**Our ref:** XA/2025/100441/03

**Your Ref:** EN010159

## **ONE EARTH SOLAR FARM**

### **RESPONSE TO DOCUMENTS SUBMITTED AT DEADLINE 4**

*Figure 2: Average water depths for the inundated panel areas in the design event (1 in 100 year plus 39% climate change). Peak water depths for the wider Trent floodplain are also shown. Depth values are in metres (m). Depths are taken from the Tidal Trent hydraulic model (Jacobs, 2023)*

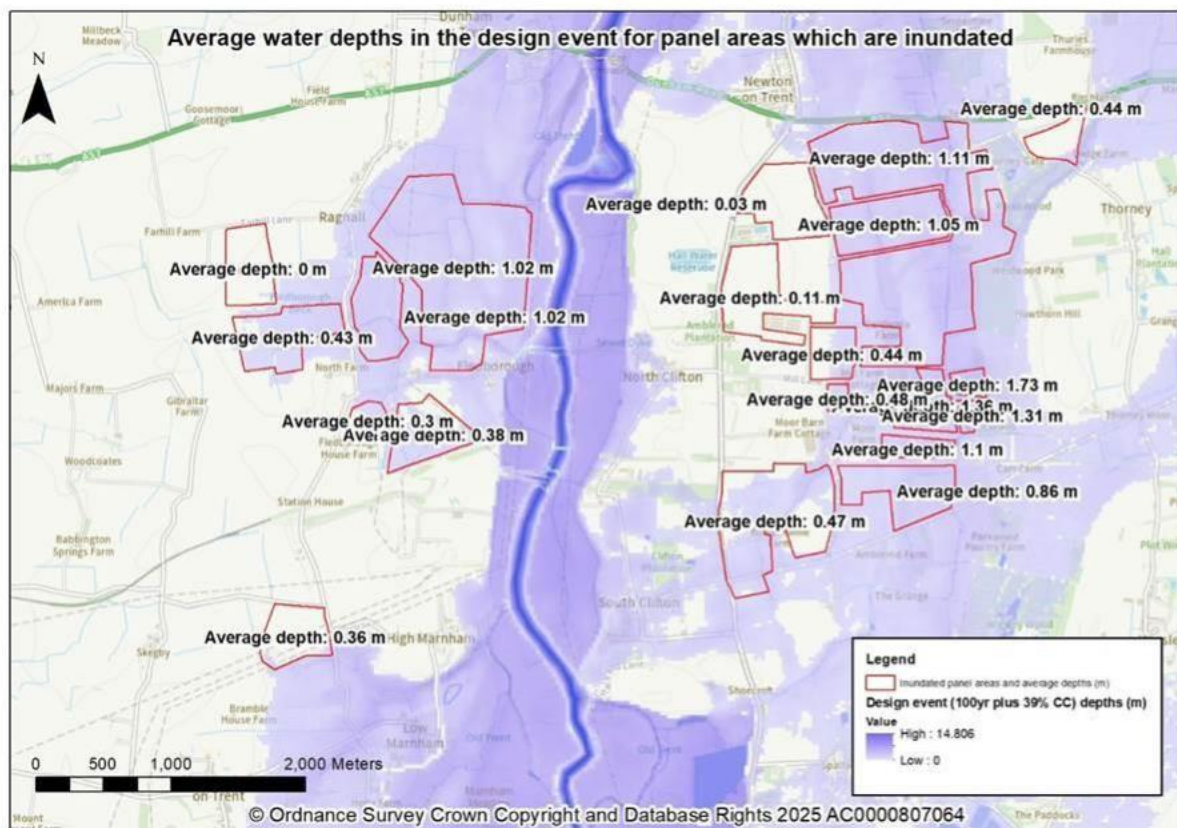
The applicant has undertaken their volumetric assessment using conservative assumptions in terms of inundated water depth (1.8 metres) and panel leg cross section (plan view) support dimensions (0.25 metres by 0.25 metres). The rationale for this approach being firstly simplicity but secondly, as the exact positioning of the solar panel support columns is not yet known it would not be possible for the applicant to determine the actual depths at each column until the detailed design stage. We consider the assumptions that the applicant has made and conservative assessment reasonable for the planning stage.

It should be noted that the average depths across the panel areas are lower than the 1.8 metres used in the applicant's calculations. Water depths are on average 0.5 metres and 0.8 metres (we note a level of 0.7 was described in Issue Specific Hearing 3 on the 6<sup>th</sup> November. This was an error) in the western and eastern floodplains of the River Trent respectively for the design event (figure 2). We expect the true impacts of the panel support frames to be less once this calculation is revisited at the detailed design stage given the outlined conservative assumptions that have been made in the calculations presented within the Flood Risk Assessment by the applicant.

*Figure 3: Peak design event (1 in 100 year plus 39% climate change) water levels for the River Trent in the vicinity of the proposed development. Water levels shown are in metres Above Ordnance Datum (mAOD). Levels are taken from the Tidal Trent hydraulic model (Jacobs, 2023)*

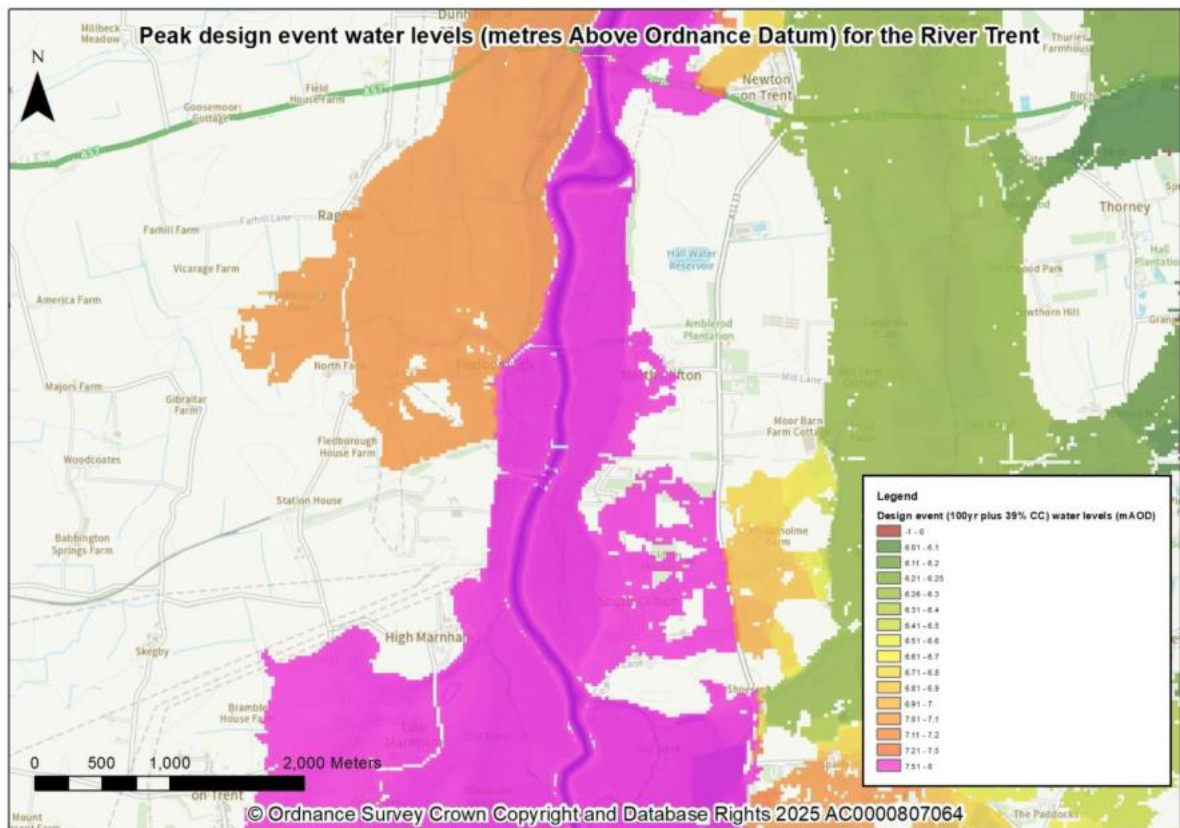
A question was raised in Issue Specific Hearing 3 on November 6<sup>th</sup> 2025 regarding why the two estimated level changes for the eastern and western floodplains have not been combined giving a resultant level increase of 5.7mm. In terms of combining the estimated level increases of 3.5mm and 2.2mm for the eastern and western floodplains respectively, this has not been undertaken because the eastern and western floodplains operate as two distinctive cells. This is evidenced by the peak water levels in metres Above Ordnance Datum (mAOD) that are observed within the respective eastern and western floodplains comparative to the River Trent (figure 3), and the timing of inundation between the eastern and western floodplains (figure 4). During the design flood event, water levels on the eastern Trent floodplain reach their maximum earlier than water levels on the western Trent floodplain. On the eastern floodplain water levels reach their maximum between 82 and 116 hours into the design event simulation and reach a peak level of between 6.2 and 6.9 metres Above Ordnance Datum (mAOD). On the western floodplain maximum levels are reached at around 127 hours and reach a peak level of just over 7 mAOD. The maps in figure 3 and figure 4 below show the difference in maximum peak water levels and differing times of inundation in further detail for the eastern and western floodplains with respect to the design event. Based on this we consider the applicant's approach of separating the volumetric calculations out into respective eastern and western floodplain areas reasonable.
